MOXLIE RISER 4

<3 SLOT- WITH 48 LANES>

STAGE: PVT
VERSION: 3.10
DATE: 2018.11.23
PCB P/N: PCB-3RSMOXL8-P0

VR:P0V9

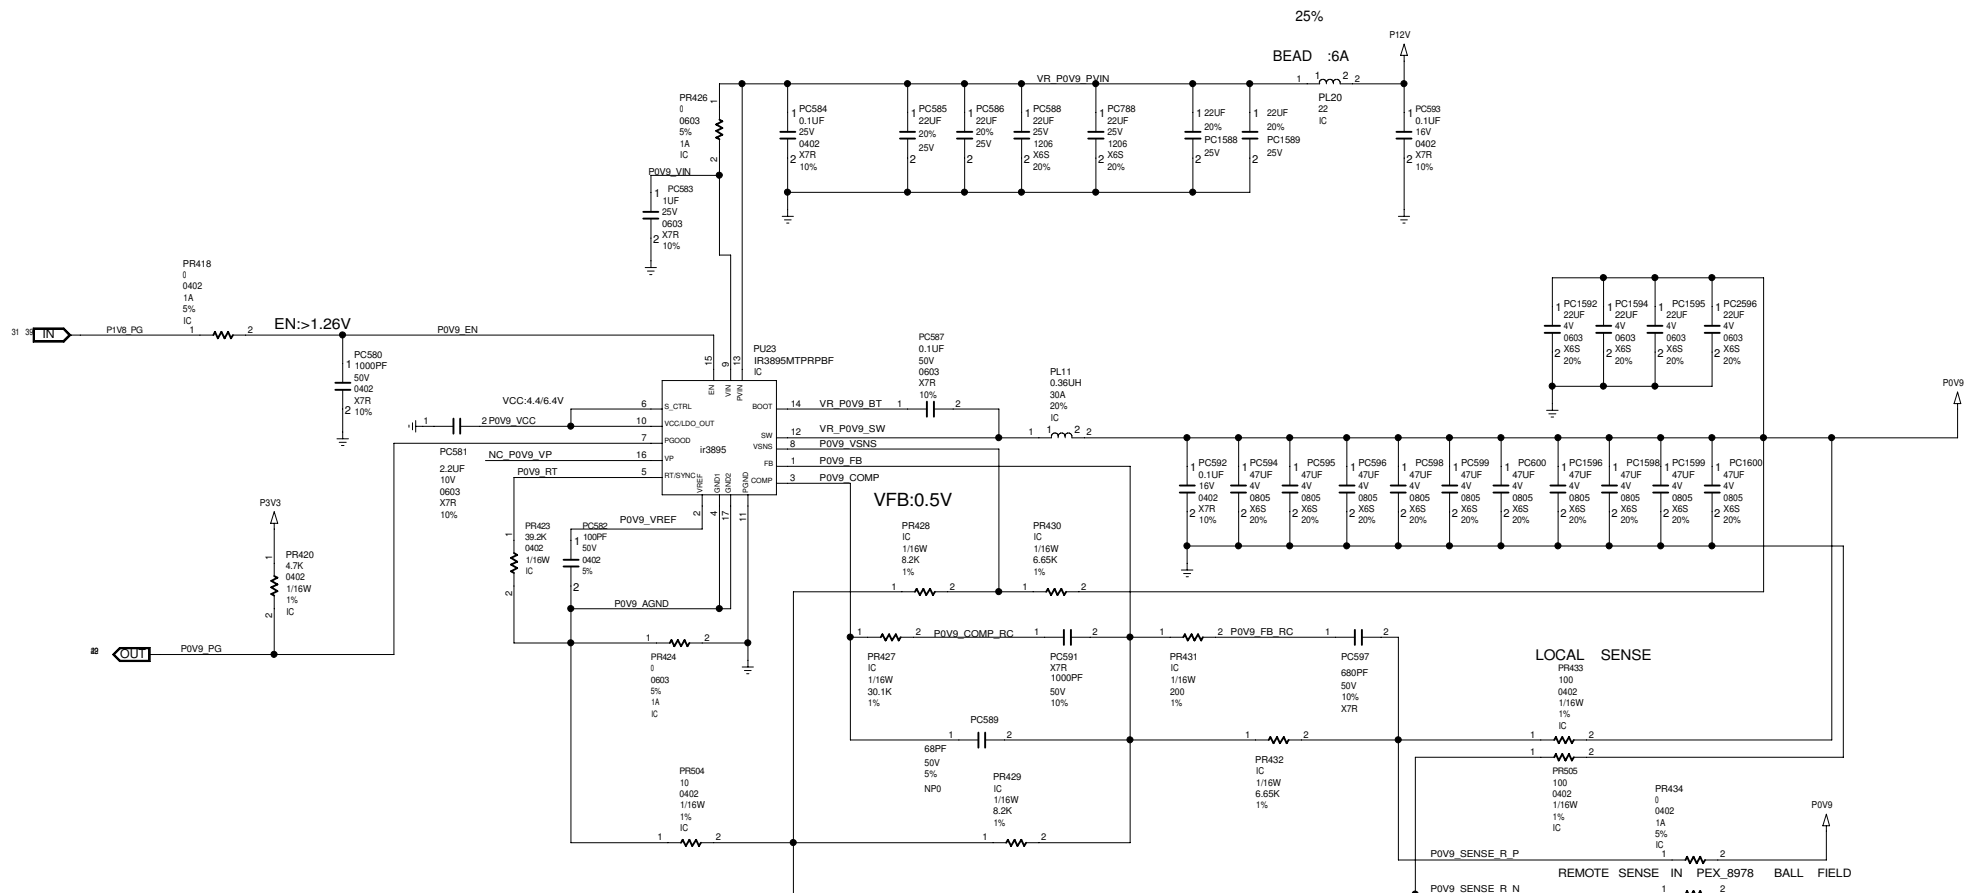
V3.10-	CHANGE	PC597	FROM	2200PF	TO	680PF	
	CHANGE	PC591	FROM	6800PF	TO	1000PF	
	CHANGE	PR431	FROM	120OHM	TO	200OHM	
	CHANGE	PR432	FROM	10.2K	TO	6.65K	
	CHANGE	PR430	FROM	10K	TO	6.65K	
	CHANGE	PR428	AND	PR429	FROM	12.4K	TO 8.2K
	CHANGE	PR427	FROM	6.19K	TO	30.1K	
	CHANGE	PC589	FROM	150PF	TO	68PF
